Docket Number:	16-AFC-01
Project Title:	Stanton Energy Reliability Center
TN #:	220821
Document Title:	Stanton Energy Reliability Center Data Request Response Set 2, for Data Requests A64 through A70
Description:	N/A
Filer:	M. Finn
Organization:	CH2M
Submitter Role:	Applicant Consultant
Submission Date:	8/17/2017 2:02:53 PM
Docketed Date:	8/17/2017

Responses to California Energy Commission Staff
Data Requests A64 through A70

Stanton Energy Reliability Center

16-AFC-1

Figure DRA70-1
Hydrology Map of Existing System
 Stanton Energy Reliability Center AFC
 Stanton, California

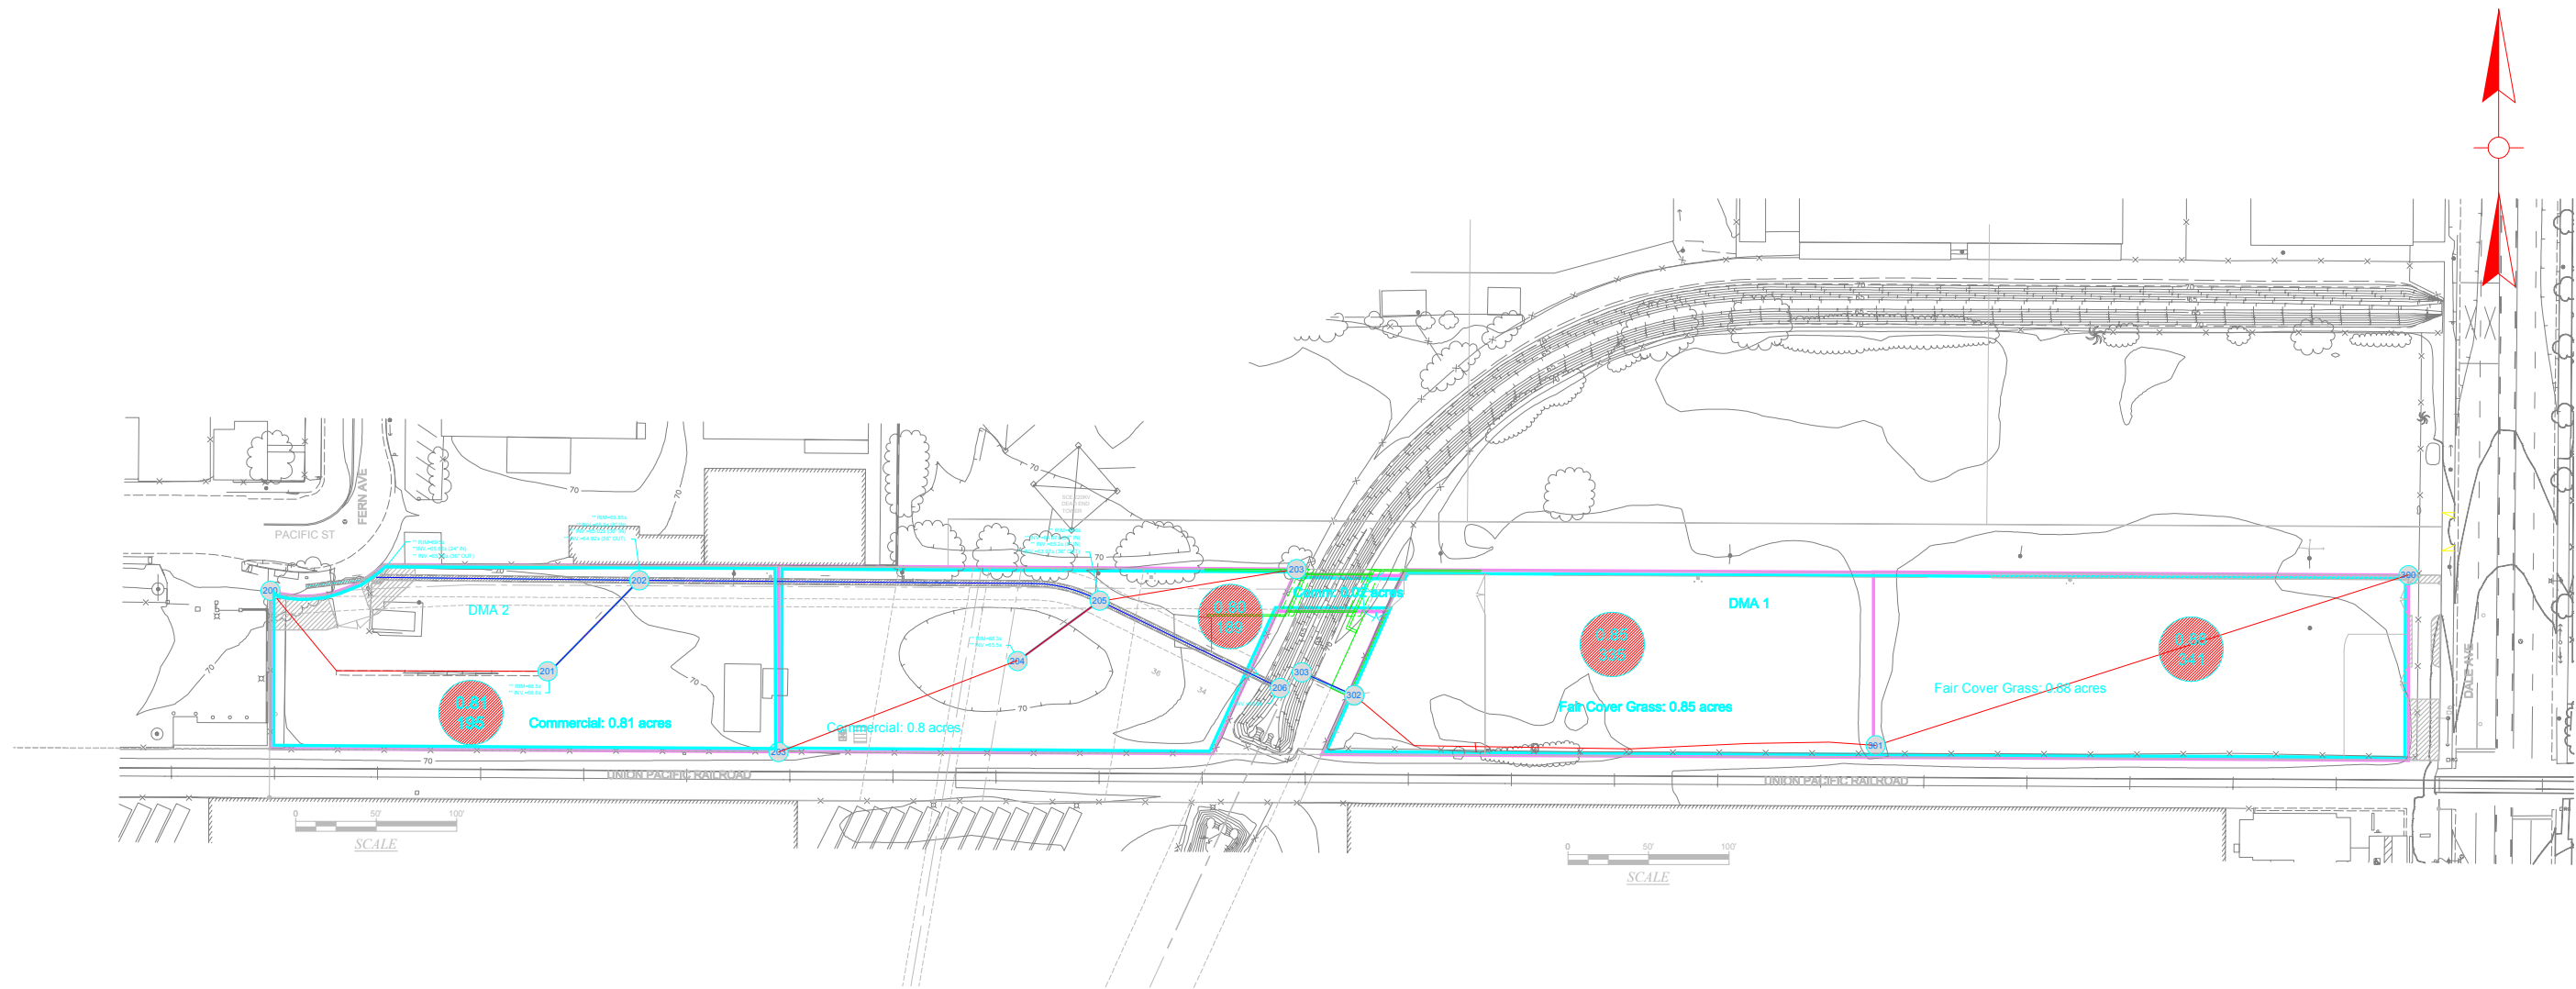
A68. Please provide information regarding location of all existing stormwater collection drains, including connector piping, flow directions, and discharge point(s). Additionally, please provide plans for the appropriate abandonment or removal of the existing stormwater drainage system prior to construction of Stanton.

Response: SERC LLC's response to Staff's Data Requests A38 included figures for each parcel showing the pre- and post-project stormwater drainage features (reproduced here as Figures DRA70-1 and DRA70-2, respectively). Parcel 2 (the western parcel) has two existing catch basins that collect stormwater, identified by Node Nos. 201 and 204 in Figures DRA70-1 and DRA70-2. The catch basins at Nodes 201 and 204 will be retained and are each independently connected via 8-inch ductile iron pipes to an existing 36-inch reinforced concrete pipe that runs from west to east just south of the northern border of Parcel 2 (connections are at Node Nos. 202 and 205, respectively). This large pipe conveys stormwater from the residential area located northwest of Parcel 2 to the Stanton Storm Channel, which passes through the east end of Parcel 2. The discharge location of the 36-inch reinforced concrete pipe is identified as Node No. 206 in Figures DRA70-1 and DRA70-2. No new catch basins are proposed for Parcel 2.

Parcel 1 (the eastern parcel) has a single existing catch basin that collects stormwater from Parcel 1 as well as the property north of Parcel 1. This catch basin, identified by Node No. 302 in Figure DRA70-1, currently discharges via an existing 24-inch corrugated metal pipe to the Stanton Storm Channel at Node No. 303 in Figure DRA70-1. Post-project, this catch basin will be reconfigured to accept only stormwater from the property north of Parcel 1 via a new 18-inch pipe that will parallel the Stanton Storm Channel. An inlet to the new 18-inch pipe will be incorporated into the structure for the new traffic bridge that will be in the northeast corner of Parcel 1. Thus, no project stormwater will flow through the existing stormwater facilities on Parcel 1.
